UNITED STATES PATENT AND TRADEMARK OFFICE

APPLICATION NO.	FILING DATE	FIRST NAMED INVENTOR	ATTORNEY DOCKET NO.	CONFIRMATION NO.
10/568,772	02/21/2006	Hirofumi Akagi	AOKI-17	6680

Office Action Summary

DETAILED ACTION

**Figure 1****Conclusion**

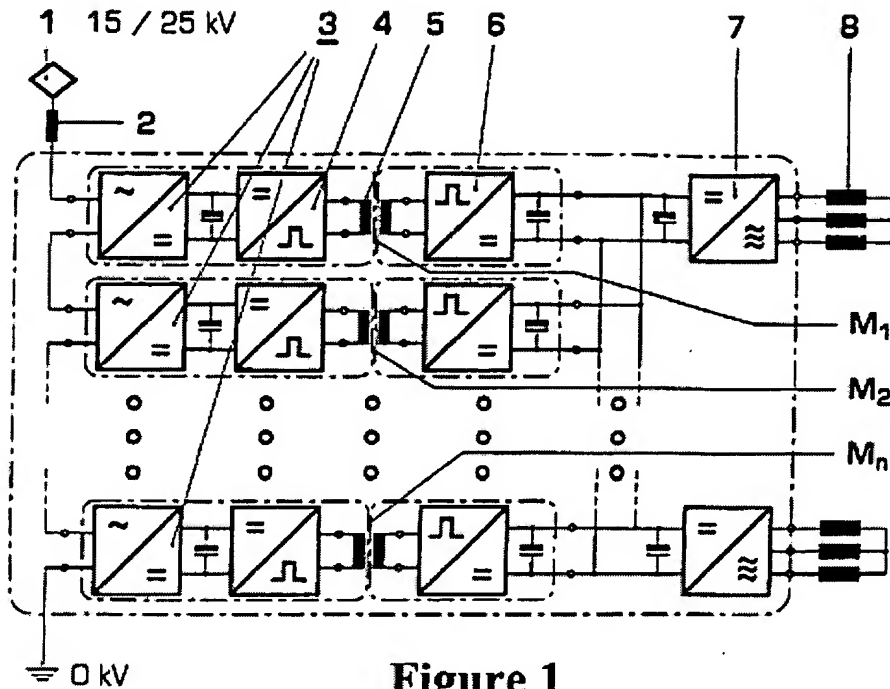
6. Claims 1-5, and 8 are rejected under 35 U.S.C. 102(b) as being clearly anticipated by Berth et al. (6,218,792). See figure 1 below. Berth discloses the converters and the transformer 5.
